THE QUINTET CONDOMINIUMS

ROOF ASSESSMENT

PONO BUILDING CONSULTANTS

August 22, 2022

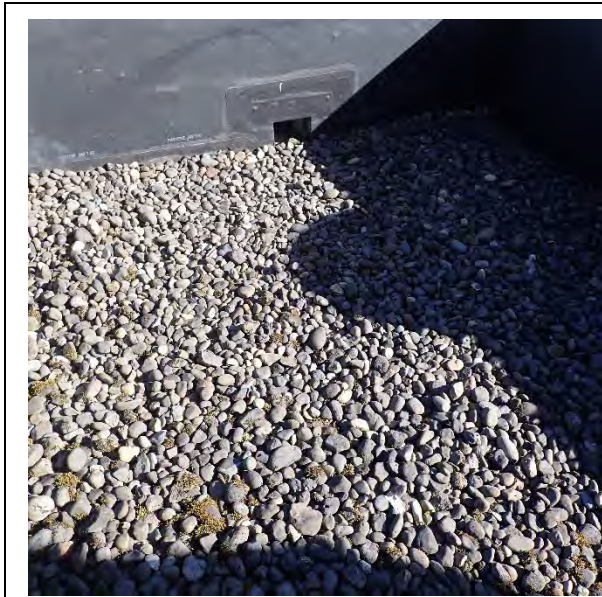
2.1A Roof sheathing is decayed. Note, previously patched holes.
Location: Clubhouse

2.1B Additional view of decayed roof sheathing with previously patched holes.

2.1C Interior view of drip ceiling sagging below damaged roof areas.

2.2 Granule loss is occurring on modified cap sheet sooner than typical. Further review is required to determine cause of premature granule loss.

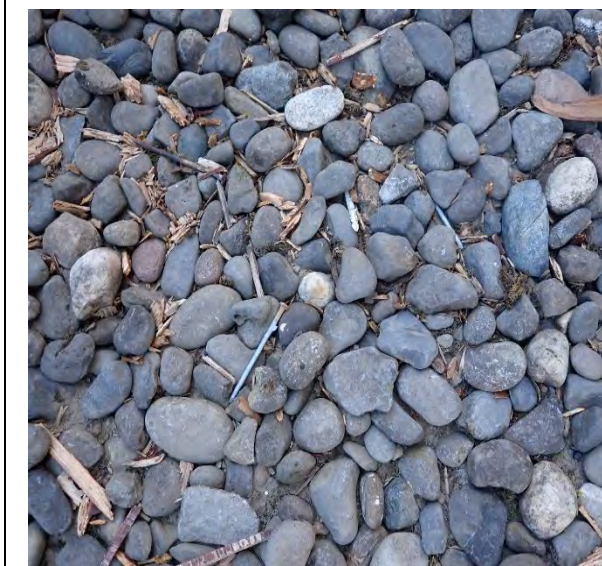
2.3 Tree extends over edge of roof. Vegetation should be trimmed back a minimum 2' from edge of roof.

2.4 Splash blocks are missing at base of downspouts on EPDM roofs.

2.5 Gravel stops at scuppers are missing, allowing rocks to enter scupper and leader boxes and preventing proper drainage.
Location: Systemic throughout property

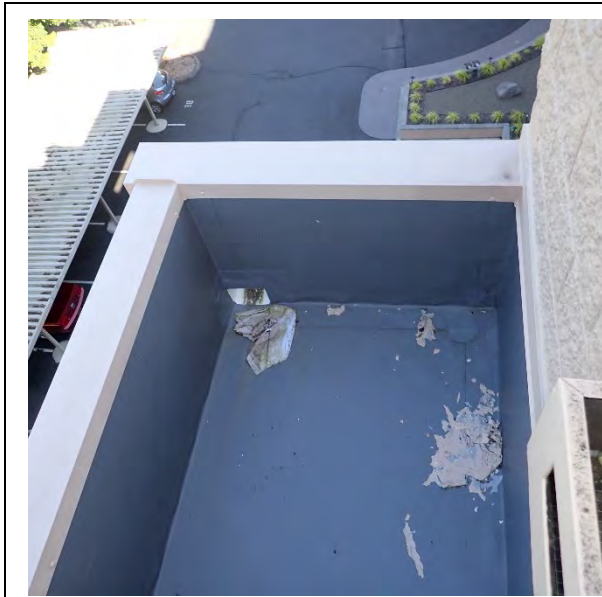
2.6 Gravel at EPDM roof is spread too thin, allowing the roof to be more exposed to UV and increasing the chance of the roof blow-off in these areas.
Location: Bldg. 4

2.7A Debris from previous tile roof repair present at gravel areas of the EPDM roof. Drop clothes and plywood should be laid down over low slope roofs when tile repairs are made to protect the membrane from damage.
Location: Bldg. 2

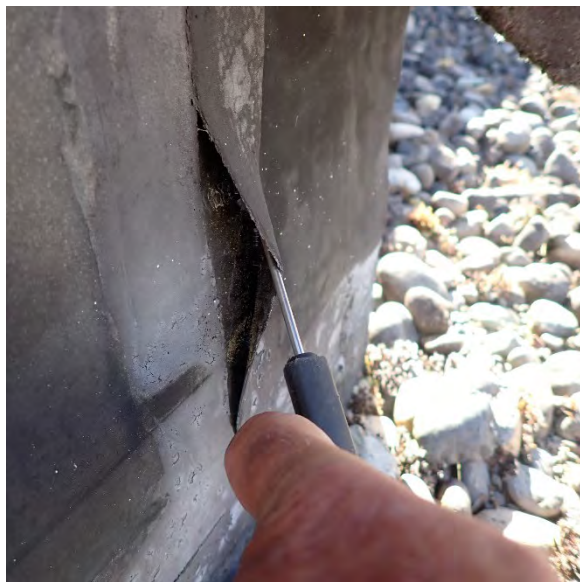
2.7B Additional example of debris from previous repairs present at EPDM roof.

2.8 Debris and towels from previous painting work left on roof. Note proximity of debris to scupper. This could block proper drainage.
Location: Bldg. 1

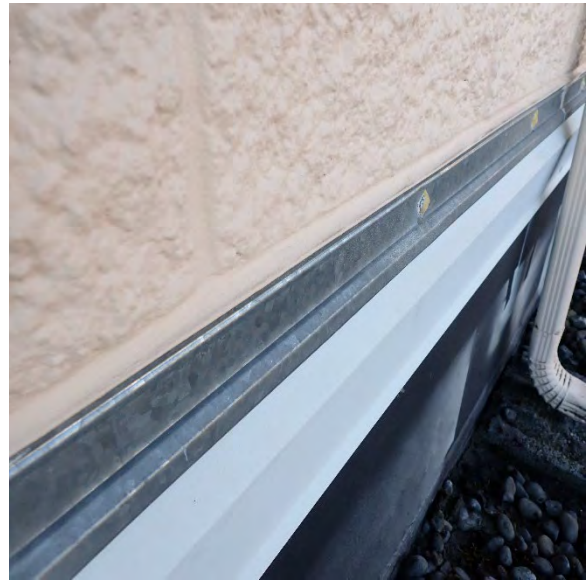
2.9A Seam at EPDM roof is lifting. All lifting or open seams should be repaired.
Location: Bldgs. 1, 3, 4

2.9B Additional example of lifting seam at EPDM roof.

2.10 Open seam present at low slope metal valley roofs between tile roofs. All lifting or open seams should be repaired.
Location: Bldg. 1

2.11 Low slope metal valley roof between tiles is corroded.
Location: Bldg. 1

2.12 Extra tiles are being stored on roof. Tiles should be removed and stored in safe location.
Location: Systemic throughout property

2.13A Lower corners of tiles are cracked and missing. Any tile with a crack over 3" should be replaced.
Location: Systemic throughout property

2.13B Closer view of damaged lower corner of tile.

2.14A Tile is missing at rake edge of roof.
Location: Bldg. 2

2.14B Additional view of missing tile at rake edge of roof.

2.15 Lead cap at for pipe flashing is missing, allowing possible water ingress.
Location: Bldg. 5

2.16A Pipe flashings on EPDM roofs have been previously repaired. Repairs to penetrations should be continued as needed until the roofs are replaced.
Location: Systemic throughout property
